RHODE ISLAND DEPARTMENT OF TRANSPORTATION

RHODE ISLAND CONTRACT NO.2013-CB-047

Statewide Bridge Repairs Contract 1

ADDENDUM NO. 1 Prospective bidders and all concerned are hereby notified of the following changes in the Plans, Specifications, Proposal and Distribution of Quantities for this contract. These changes shall be incorporated in the Plans, Specifications, Proposal and Distribution of Quantities, and shall become an integral part of the Contract Documents.

TITLE OF SKETCH
 STATEWIDE BRIDGE REPAIRS
 CONTRACT 1
 CHICKASHEEN BRIDGE NO. 183
 REPAIR DETAILS-1

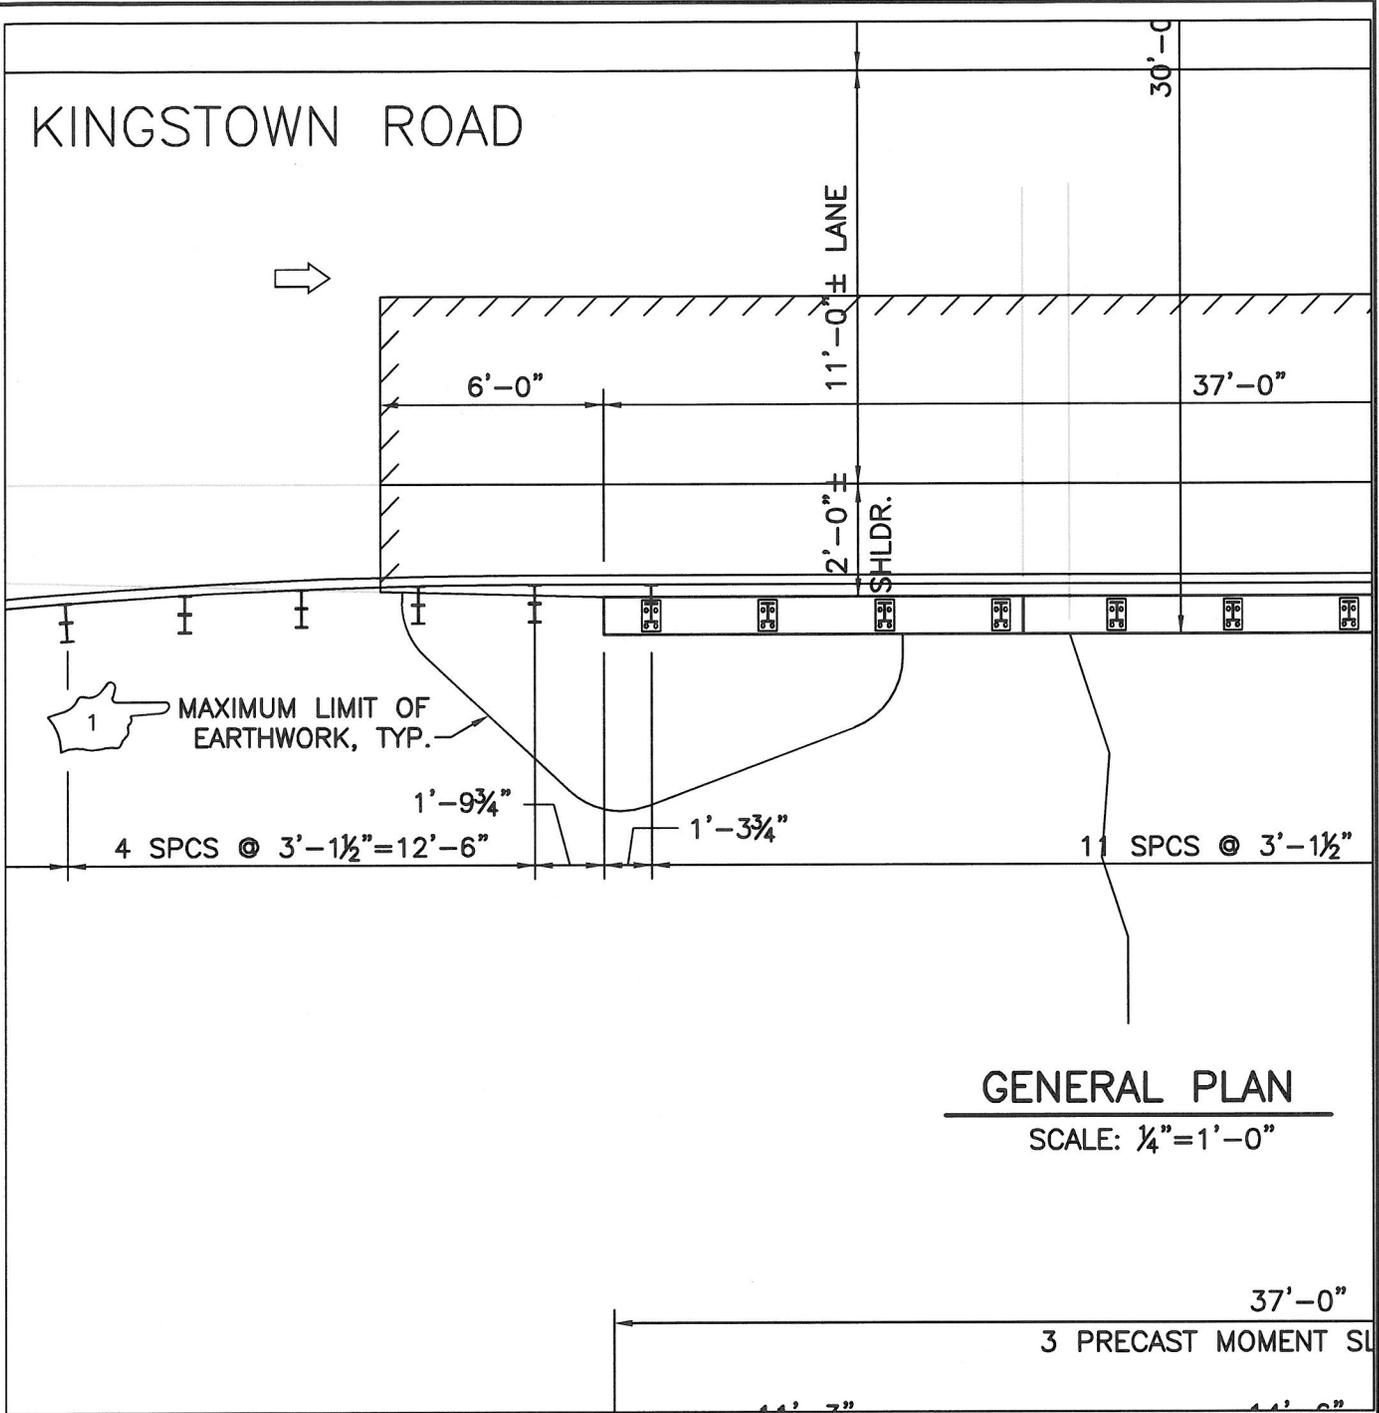
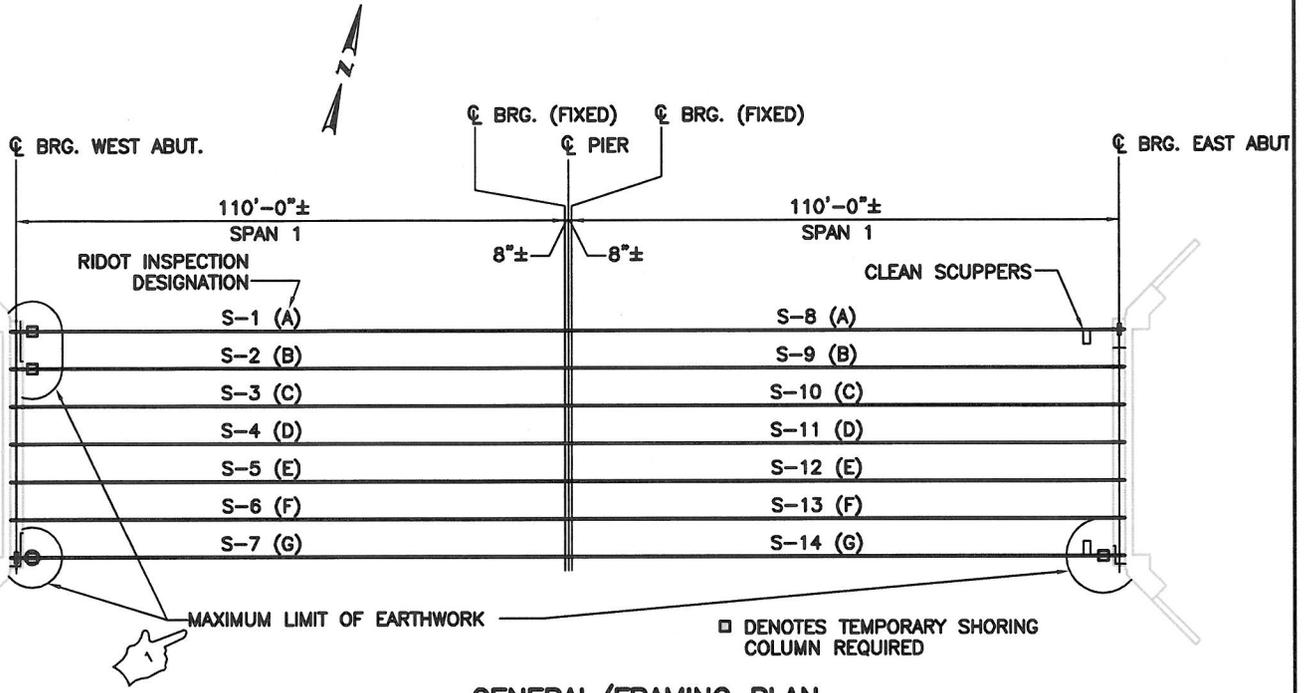
1. Sheet No. 16 – Chickasheen Bridge No. 183, Repair Details-1

Revise Sheet No. 16 as shown on Sketch No. 1(R-1) attached to this Addendum No. 1. The call-out for Limit of Earthwork has been revised.

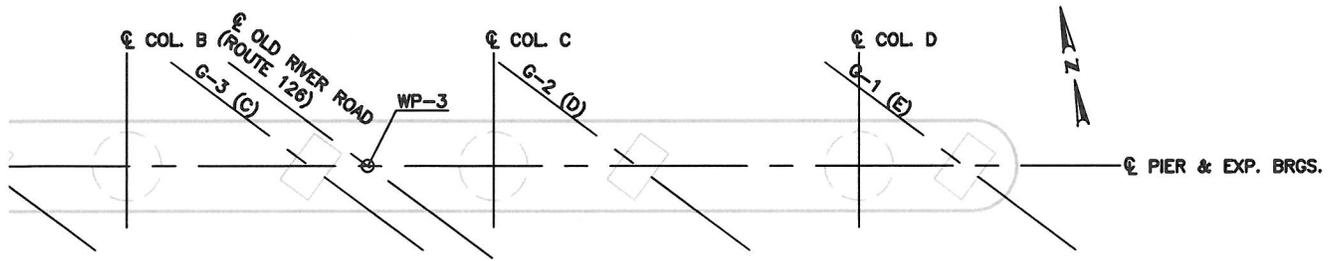
2. Sheet No. 21 – Mohegan Bridge No. 673, Repair Details-1

Revise Sheet No. 21 as shown on Sketch No. 2(R-1) attached to this Addendum No. 1. The call-out for Limit of Earthwork has been revised.

Gordon R. Archibald, Inc. Civil and Environmental Engineers Pawtucket, Rhode Island	TITLE OF SKETCH STATEWIDE BRIDGE REPAIRS CONTRACT 1	R.I. CONTRACT NO. 2013-CB-047
	OLD RIVER ROAD BRIDGE NO. 749 REPAIR DETAILS-4	SKETCH NO. 3
DATE: 8/13/2013	ADDENDUM NUMBER 1	SHEET NO. 35

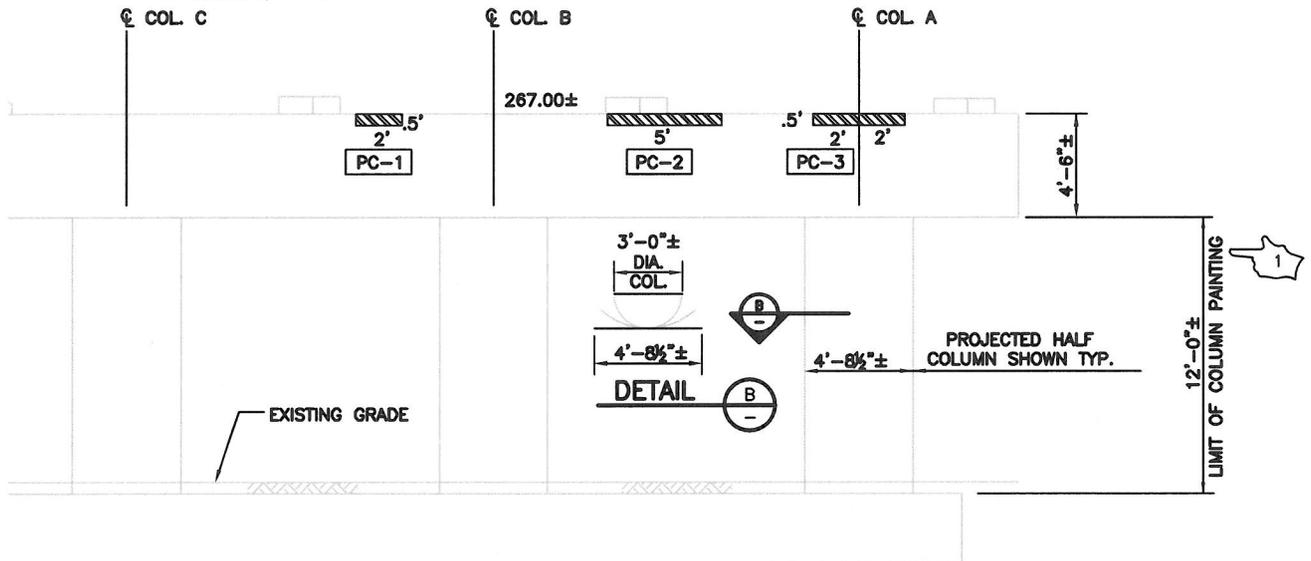
3. Sheet No. 35 - Old River Road Bridge No. 749, Repair Details - 4
Revise Sheet No. 35 as shown on Sketch No. 3(R-1) attached to this Addendum No. 1. The callout for FRP on the Elevation view has been deleted.
4. Sheet No. 37 – Middle Road Bridge No. 761, Repair Details-1
Revise Sheet No. 37 as shown on Sketch No. 4(R-1) attached to this Addendum No. 1. The Summary of Work has been revised.
5. Sheet No. 38 – Middle Road Bridge No. 761, Repair Details-2
Revise Sheet No. 38 as shown on Sketch No. 5(R-1) attached to this Addendum No. 1. Pedestal Repair Details have been added.
6. Sheet No. 61A – Middle Road Bridge No. 761, Traffic Control Plan-2
Insert Sheet No. 61A attached to this Addendum No. 1 immediately after Sheet No. 61. Additional details and notes have been provided for control of traffic.
